Read Avenue Outfalls Repair Project Project Review, Update and Recommendations

November 8, 2023

READ AVENUE
 CONSTRUCTION PLAN

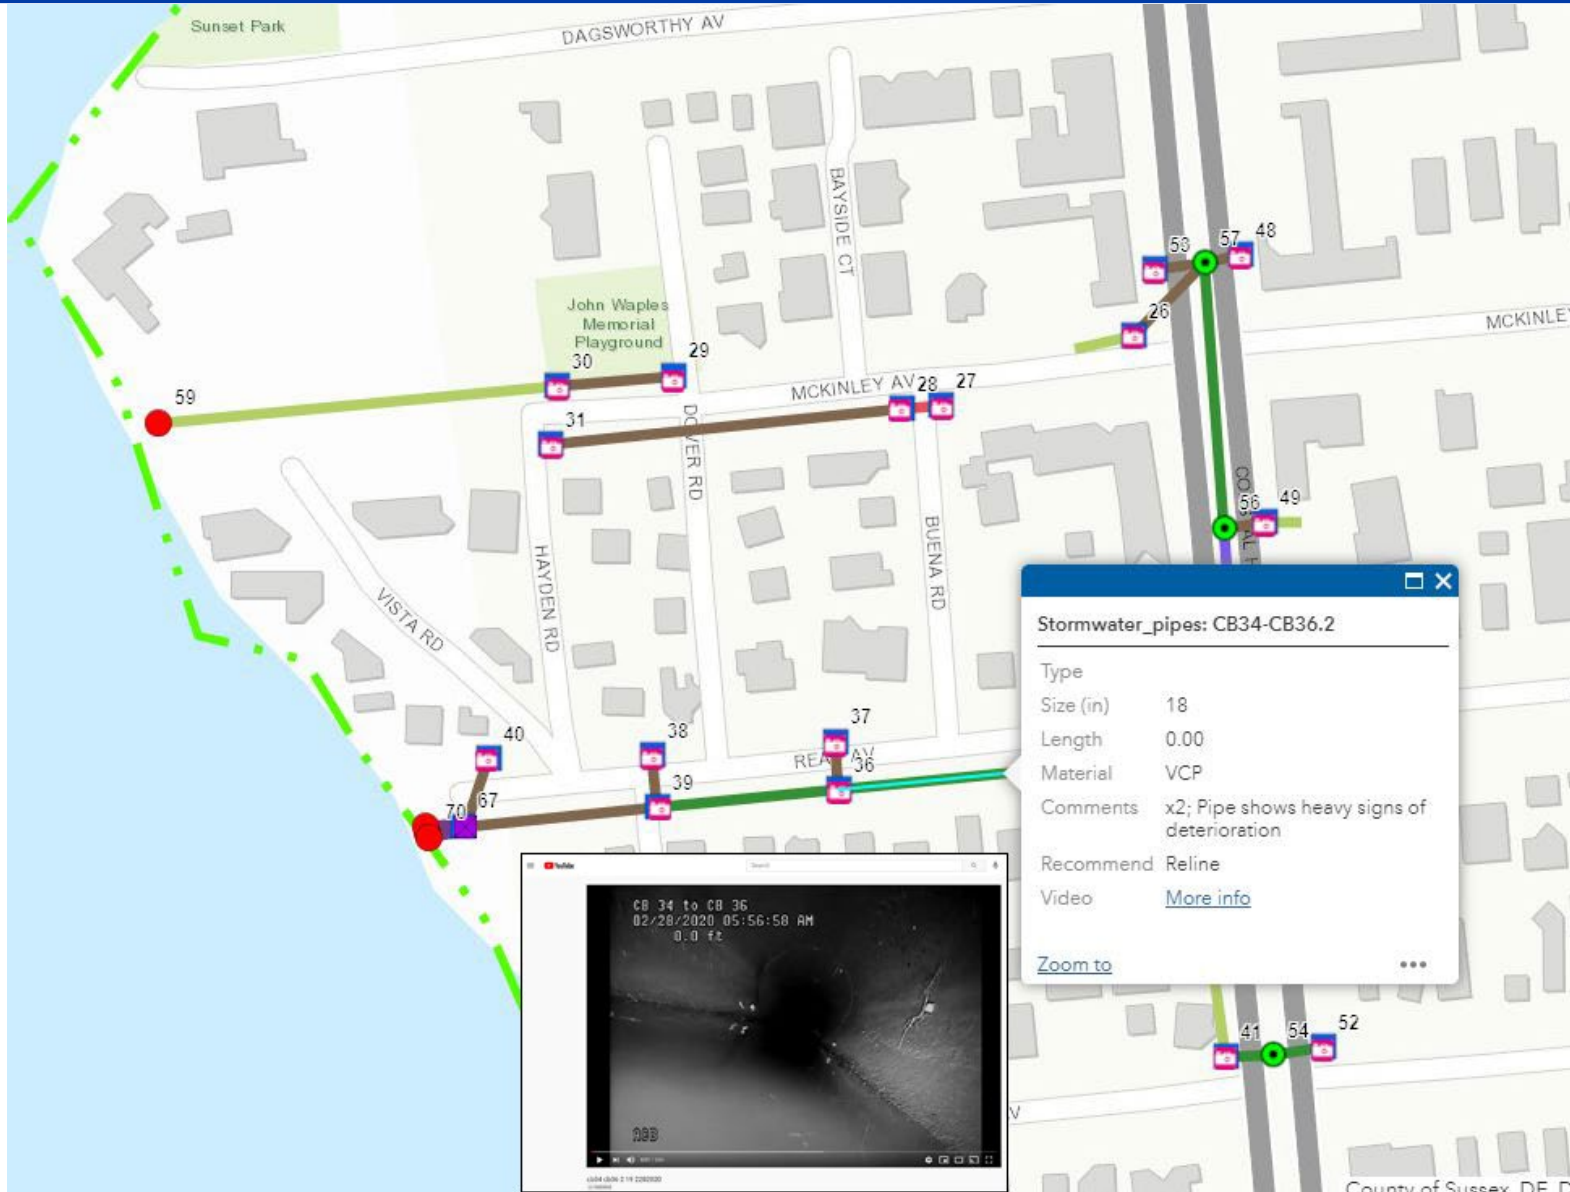
The red shows removal to help rebuild the canoe path. The green shows the riprap repair.

The red shows removal to help rebuild the canoe path. The green shows the riprap repair.
